## AGENDA ITEM 13

**DATE:** February 21, 2020  
**TO:** Transportation Authority Board  
**FROM:** Eric Cordoba- Deputy Director for Capital Projects  
**SUBJECT:** 2/25/20 Board Meeting: Independent Management and Oversight Report on the San Francisco Municipal Transportation Agency’s Siemens Light Rail Vehicle Procurement

**PROGRAM MANAGEMENT OVERSIGHT REPORT**

**SFMTA LIGHT RAIL VEHICLE PROCUREMENT**

*Exhibit 2 - Old Design – Brackets at same plane as bottom of APS*

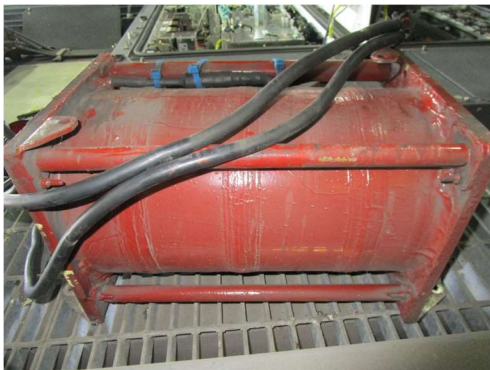
The root cause was determined to be the mounting of the APS unit. The APS unit brackets placed the bottom of the APS unit at approximately the same plane as the bottom of the compartment [*Exhibit 2*]. Therefore, water would accumulate in the compartment and not be able to get under/past the APS unit to the drain, splash into the APS and arcing would occur. The water volume, although minimal, was enough that during car movements the water would splash into the APS unit and the APS unit would fail. Note that the APS unit requires air circulation for cooling and is therefore not sealed from water.

In order to provide clearance for water to be drained underneath the APS, the mounting ears that were integral to the APS frame were removed and new brackets were designed and attached to the APS frame that slightly raised the APS off the floor of the APS line choke compartment [*Exhibits 3 and 4*]. The compartment provides for the additional APS height and the cover and car clearance are not impacted.

*Exhibit 8 – Collector Assembly with Shunts and Nordlock Washers installed*

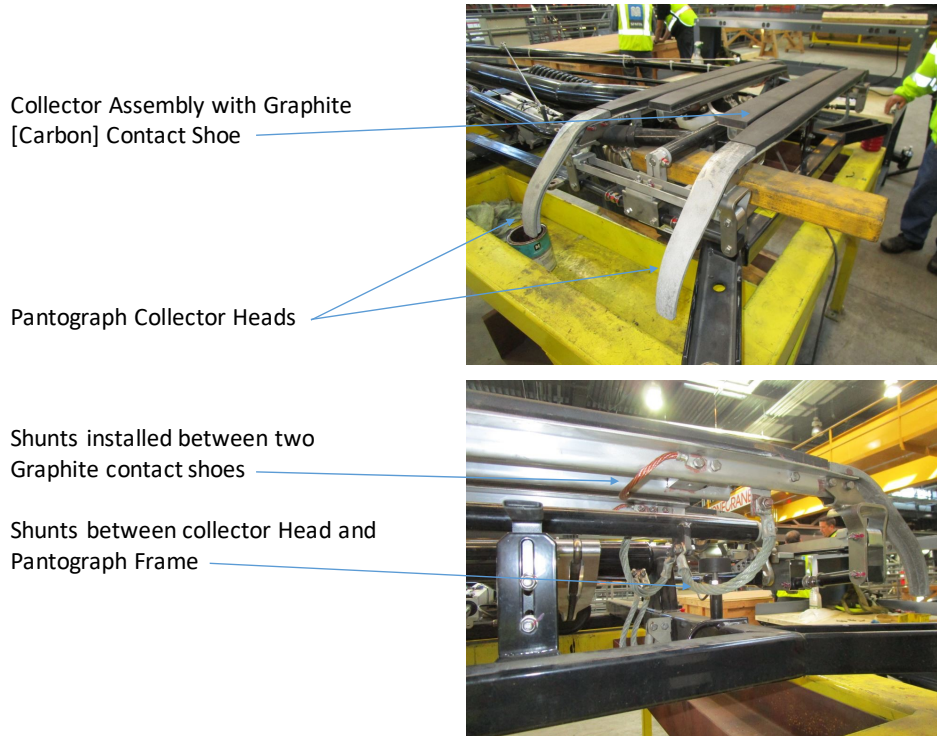
The failure occurred when energy moved through the slide plate mounting bolts that were installed using Nylock nuts. The nylon on the nuts failed because they overheated from the current, which resulted in a slide plate partially separating from the pantograph frame. Because the car was in a tunnel and the pantograph collector head was only two feet above the car roof, the slide plate touched the roof of the car causing a fault.

There were two root causes for this fault. First, hardware such as the Nylock nuts should not have been used in this application because the pantograph is fully charged. Second, in this application, the current should not be going through hardware but through shunts. Shunts are devices such as cables that provide a low resistance path for electric current.

Although there was only one such failure in the system, because of the severity of the failure and the potential to damage not only a car but also the catenary, all Nylock nuts on the pantographs were replaced with metal Nordlock washers and standard nuts. Also, eight (8) shunts were installed on each pair of collector heads to direct the path of the current from the graphite collectors and blocks through the shunts to the pantograph arms, thereby moving the current around the mounting hardware.

*Exhibit 9 – Fingers shown on door pinch point*

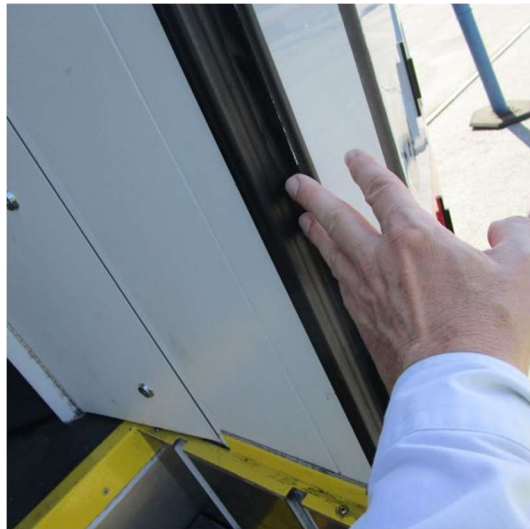
The door design with only one sensitive edge strip left a gap at the interlock point when the door closes where an object or hand could be pinched. [*Exhibits 9 & 11*].

It was determined that if additional sensitive edge strips were incorporated both in the gap where the pinch point existed and on the edge of the door [*Exhibits 10 & 12*], any object in the path of a closing door would be detected and reverse the door's operation.

*Exhibit 12 – Sketch of Modified Door Design*

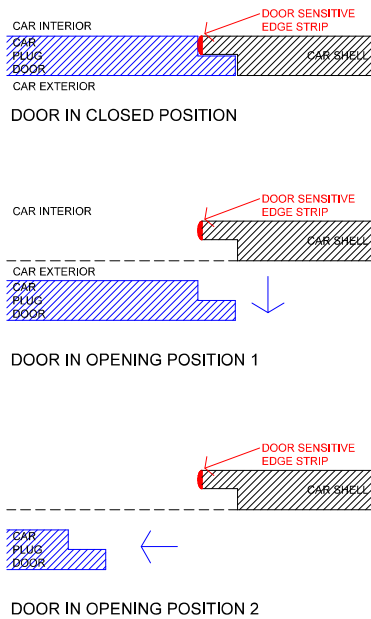
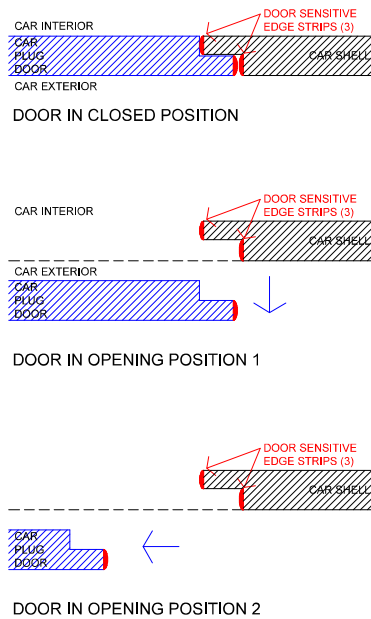
In the original design there was one sensitive edge strip installed on the door frame that is attached to the car body [Exhibit 11]. The strip was the full height of the door. When touched by an object or person when the door is closing, the pressure on the strip signals to door to stop and reverse back to the open position.

*Exhibit 14 – Lateral Stop and Upper Clam Shell Damage*

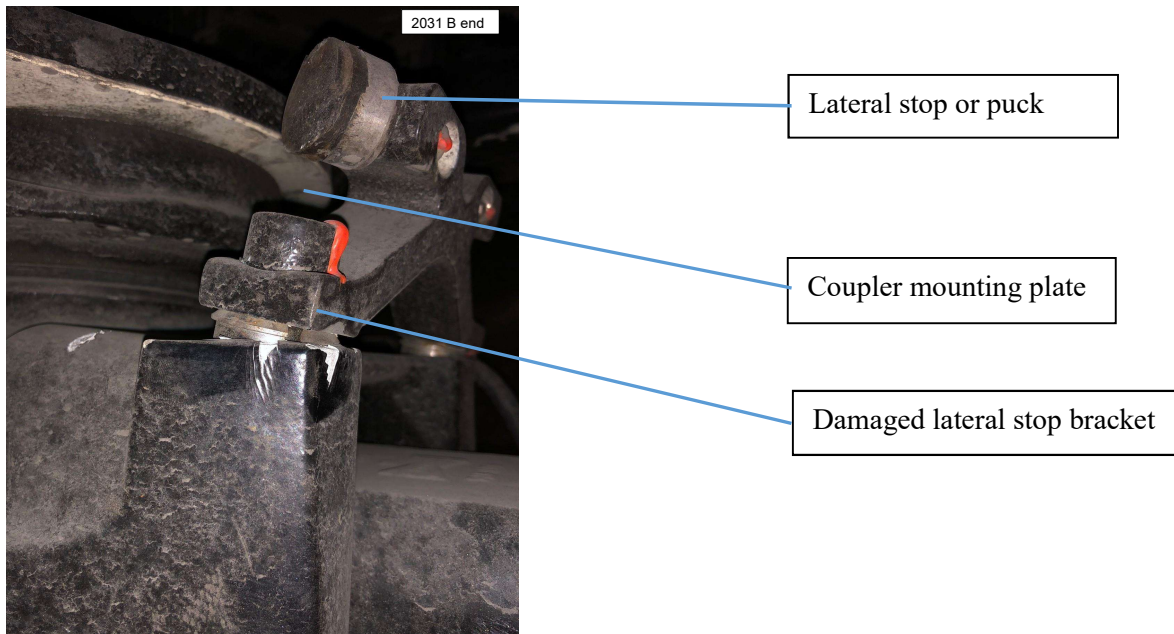
The only unusual variable that appeared in the inspections is that the lateral stop bracket, which limits the coupler horizontal swing during maintenance had been damaged and partially detached [Exh. 14]

Exhibit 14 also shows that the rubber piece on the stop, which is called a puck, is larger than the lateral stop bracket and is at the height of the coupler mounting plate. Note also that the coupler mounting plate, which is part of the car not the coupler, extends beyond the coupler assembly, which mounts to the plate.

Second, the 2mm clearance between the lateral stop bracket puck and the coupler mounting plate was deemed insufficient. Therefore, because the stop bracket is only a bump stop to keep the coupler from damaging car underframe parts when a maintenance worker swings the coupler out of the way for servicing the car, a smaller diameter replacement puck that would not extend beyond the height of the lateral stop bracket would be adequate [*Exhibit 17*]. This would increase the clearance between the puck and the mounting plate to 7mm.

*Exhibit 15 – Cross Section through Coupler Bearing Housing*

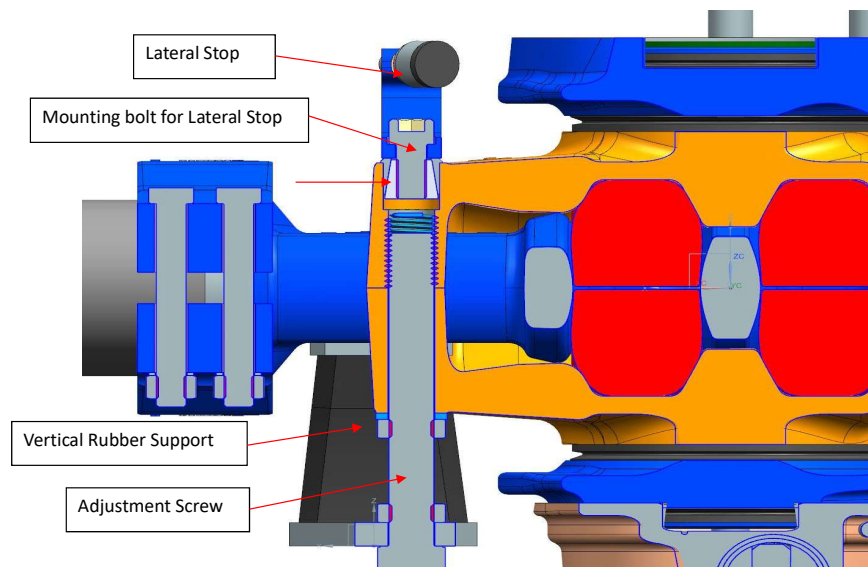
Further investigation into the engineering of the stop bracket mounting determined that the mounting bolt for the lateral stop bracket and the adjusting bolts for the coupler inclination occupied the same hole. If the coupler adjustment bolt was over tightened, compressing the rubber vertical support, the bolt would push the mounting bolt for the stop bracket out. With only 2mm clearance available between the puck and the coupler mounting plate, this was determined to be the root cause for the failure of the coupler.

Third, in order to prevent the adjustment screw from being over tightened due to, for example, not coupler height but wear of the rubber support, a sleeve spacer was installed on the Adjustment Screw to prevent the Adjustment Screw from being tightened such that it engages and pushes the mounting bolt for the lateral stop out of the clamshell [Exhibit 18].
